UNITED STATES
DEPARTMENT OF THE INTERIOR
BUREAU OF LAND MANAGEMENT

SUNDRY NOTICES AND REPORTS ON WELLS
Do not use this form for proposals to drill or to re-enter an abandoned well. Use form 3160-3 (APD) for such proposals.

Lindrith 24 2 23 #1 (30-039-31336)

Sundry Notice Changes for directional well

Texakoma E & P, LLC
Rio Arriba, NM (NAD 83)
Lindrith 24-2-23 #1
Plan 2
GL: 7284' + Est RKB:20'

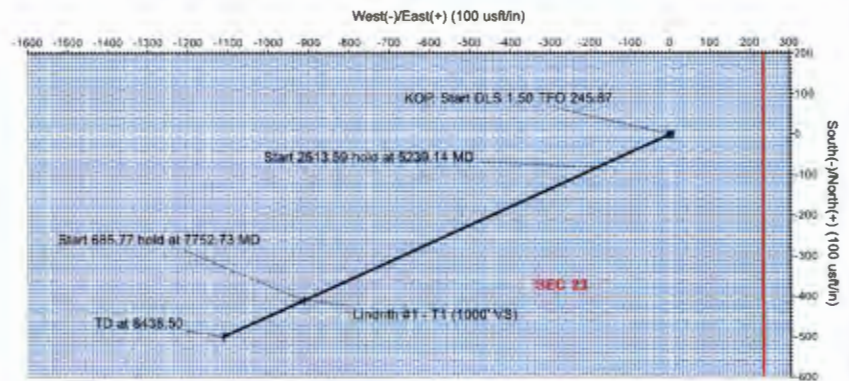
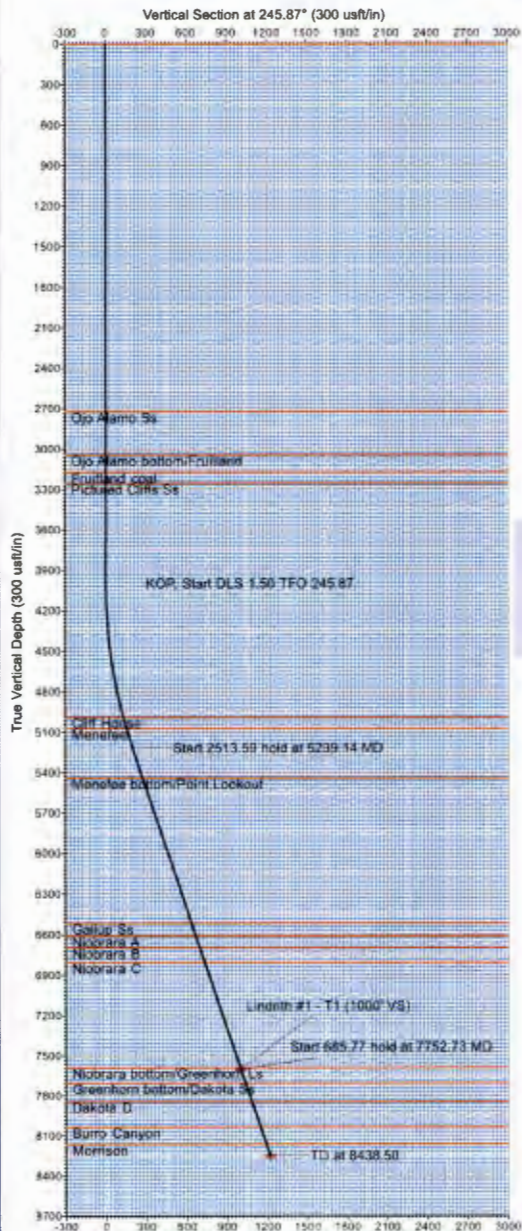
10. Directional Well Plan is attached.
